SUBJECT: THREE MILE ISLAND NUCLEAR STATION, UNIT 1 - STAFF ASSESSMENT OF INFORMATION PROVIDED PURSUANT TO TITLE 10 OF THE *CODE OF FEDERAL REGULATIONS* PART 50, SECTION 50.54(f), SEISMIC HAZARD REEVALUATIONS FOR RECOMMENDATION 2.1 OF THE NEAR-TERM TASK FORCE REVIEW OF INSIGHTS FROM THE FUKUSHIMA DAI-ICHI ACCIDENT (TAC NO. MF3905)

STAFF ASSESSMENT BY THE OFFICE OF NUCLEAR REACTOR REGULATION

RELATED TO SEISMIC HAZARD AND SCREENING REPORT

THREE MILE ISLAND NUCLEAR STATION, UNIT 1

Figure 3.3- 1 Plot of Staff's and Licensee's Base Case Shear-Wave Velocity Profiles for the TMI Site

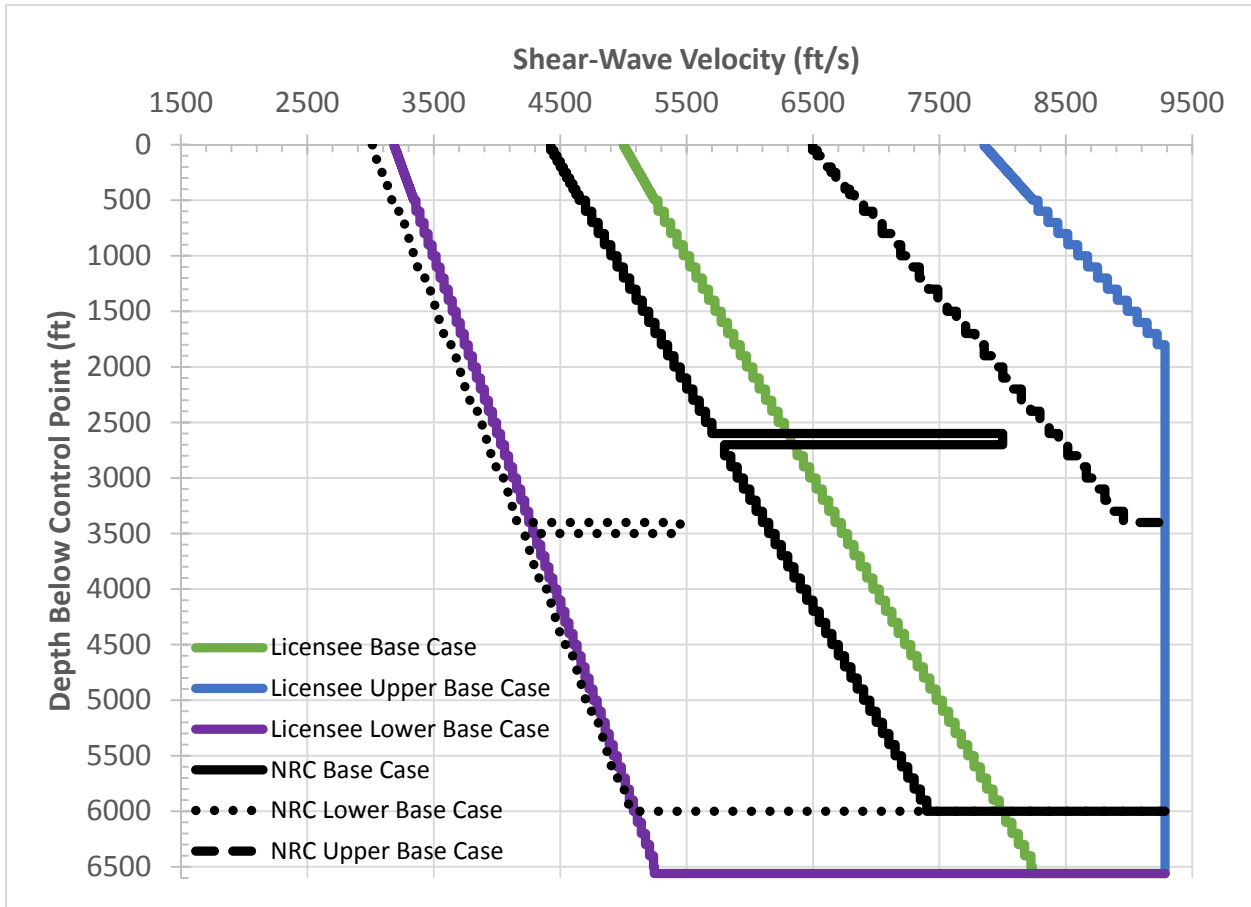
To characterize the subsurface geology, the licensee developed three site base case profiles. The middle, or best estimate, profile was developed using a shallow velocity of 5,000 fps (1,524 m/s) reflecting a Poisson ratio of 0.35 and assumed a shear wave velocity gradient of 0.5 m/s/m. Upper and lower base case profiles were developed using a scale factor of 1.57 to reflect a natural log standard deviation of 0.35. Figure 3.3-1 of this assessment shows the licensee's three shear-wave velocity base case profiles.

Following guidance provided in the SPID for sites with less subsurface information, the staff independently determined best-estimate and upper and lower base case shear-wave velocity profiles. The NRC staff based its best-estimate velocity profile on information in the TMI UFSAR and guidance provided in the SPID. The staff modeled the velocity at the top of rock with a shear-wave velocity of 4,425 fps [1,349 m/s]. This velocity corresponds to a Poisson's ratio of 0.37, given an average compressional wave velocity of 9,700 fps [2,957 m/s], which is based on seismic refraction profiles in the TMI UFSAR. Consistent with guidance in the SPID, the NRC staff used a velocity gradient of 0.5 fps/ft to model the increase in shear-wave velocity with depth. Based on geologic maps of the region surrounding the TMI site (Bert, et al., 1980; Miles, et al., 2001), the NRC staff included a layer of diabase in the site profiles. Because the depth of this layer beneath the TMI site is uncertain, the NRC staff included it at a different depth in each base case. The NRC staff used a natural log standard deviation of 0.3 to calculate upper and lower base case velocity profiles. Figure 3.3-1 of this assessment shows a comparison of the three profiles developed by the licensee with those developed by the staff. Overall, the profiles developed by the NRC staff are weighted towards slightly lower velocities than those assumed by the licensee. The NRC staff randomized the depth to reference rock by ± 10 percent to allow for additional uncertainty.

Figure 3.3- 2 Plot Comparing the Staff's and the License's Median Amplification Functions and Uncertainties for Two Input Loading Levels for the TMI Site

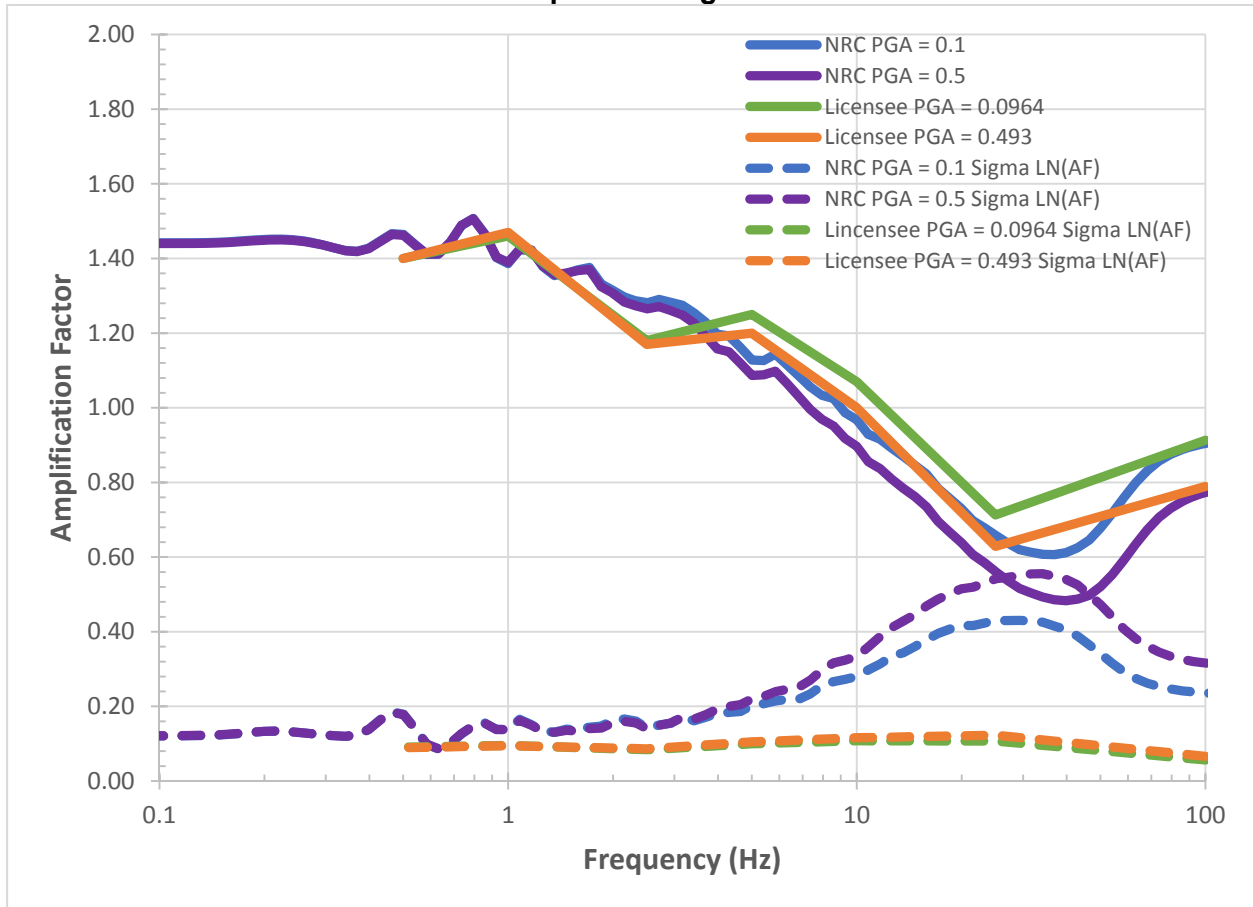
Figure 3.3-2 of this assessment shows a comparison of the NRC staff's and the licensee's median site amplification functions and uncertainties (± 1 standard deviation) for 2 of the 11 input loading levels. The amplification functions are highest at frequencies of less than 1 Hz and decrease with increasing frequency. Amplification functions calculated by the NRC staff and the licensee are similar, however uncertainties are higher for the staff's profiles. This is due to the greater epistemic uncertainty in the staff's kappa values and damping parameters.

Figure 3.3-3 Plot Comparing the Staff's and the Licensee's Mean Control Point Hazard Curves at a Variety of Frequencies for the TMI Site

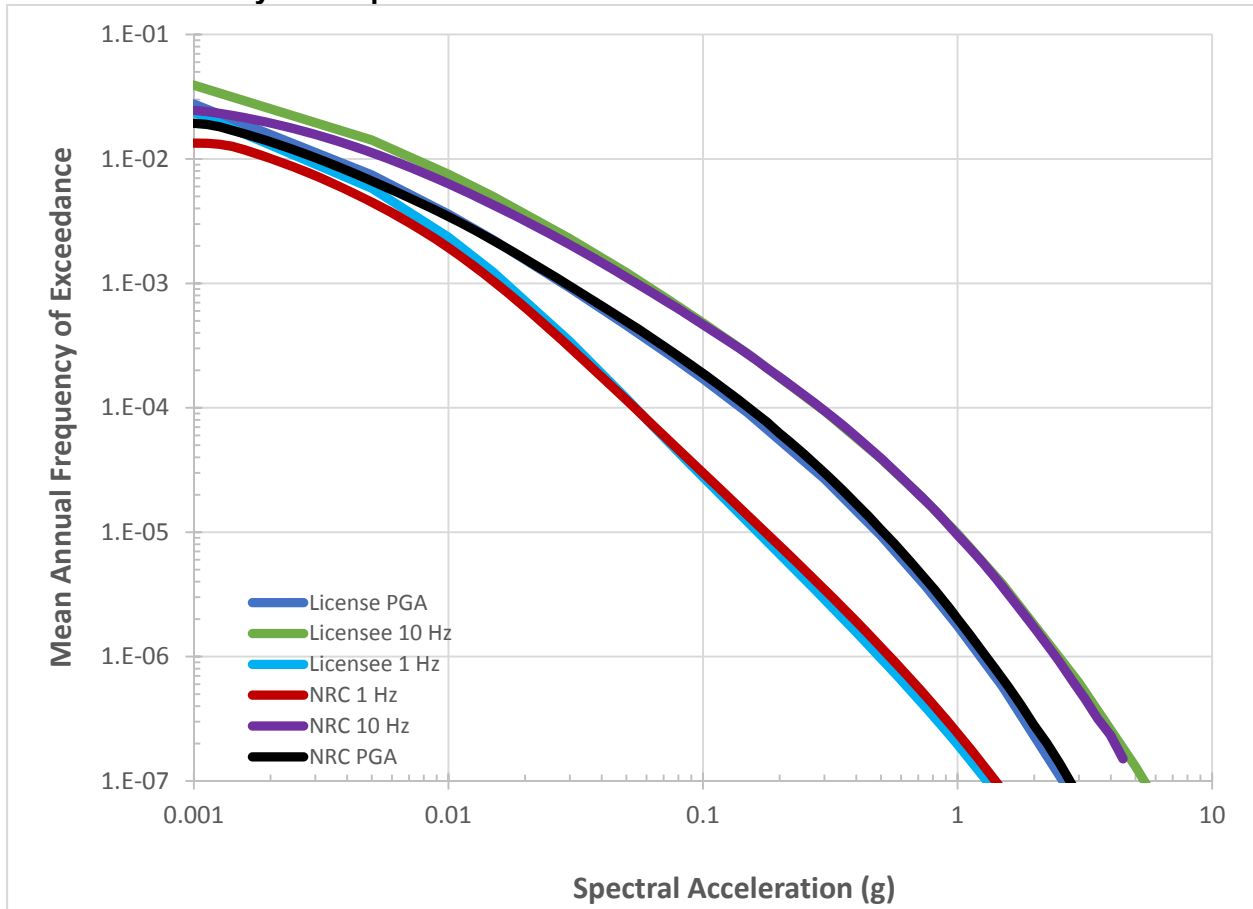
The licensee's approach to modeling the subsurface rock properties and their uncertainty results in similar site amplification factors to those produced by the NRC staff. As shown in Figure 3.3-3 of this assessment, minor differences in site amplification and uncertainty has a very minor impact on the control point seismic hazard curves and the resulting GMRS, discussed below. Appendix B of the SPID provides guidance for performing site response

Figure 3.4-1 Comparison of the Staff's GMRS with Licensee's GMRS and the SSE for the TMI Site

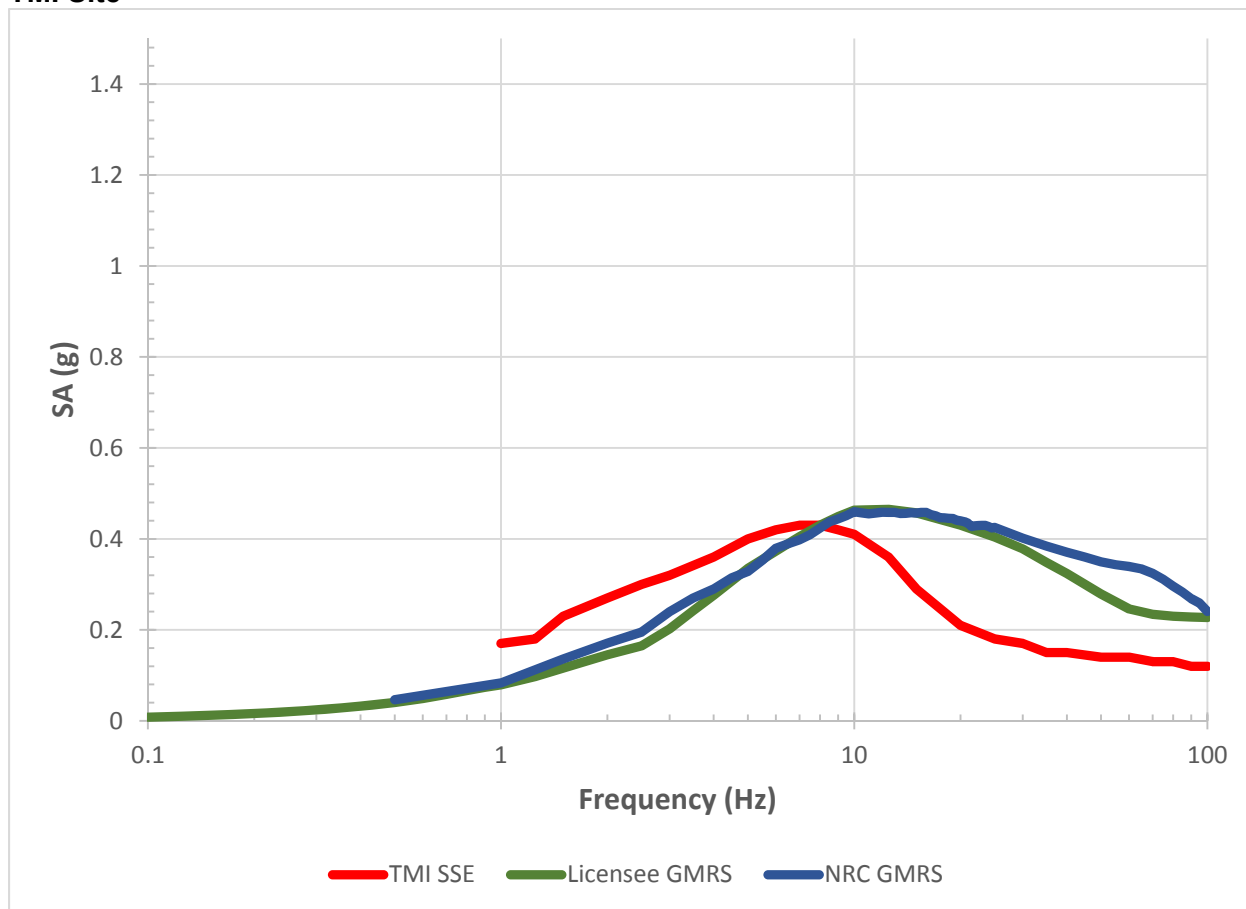
The NRC staff independently calculated the 10^{-4} and 10^{-5} UHRS using the results of its confirmatory PSHA and site response analyses, as described in Sections 3.2 and 3.3 of this assessment, respectively. Figure 3.4-1 of this assessment shows a comparison of the GMRS determined by the licensee to that determined by the NRC staff.

As shown in Figure 3.4-1, the licensee's and NRC staff's GMRS shape are very similar. The licensee's GMRS is somewhat lower than the NRC staff's confirmatory analysis at varying frequencies, particularly above 25 Hz. As described above in Section 3.3, the NRC staff concludes that these minor differences over this frequency range are primarily due to the differences in the site response analyses performed by the licensee and NRC staff.

The NRC staff confirms that the licensee used the present-day guidance and methodology outlined in RG 1.208 and the SPID to calculate the horizontal GMRS, as requested in the 50.54(f) letter. The NRC staff performed both a PSHA and site response confirmatory analysis and achieved results consistent with the licensee's horizontal GMRS. As such, the NRC staff concludes that the GMRS determined by the licensee adequately characterizes the reevaluated hazard for the TMI site. Therefore, this GMRS is suitable for use in subsequent evaluations and confirmations, as needed, for the response to the 50.54(f) letter.
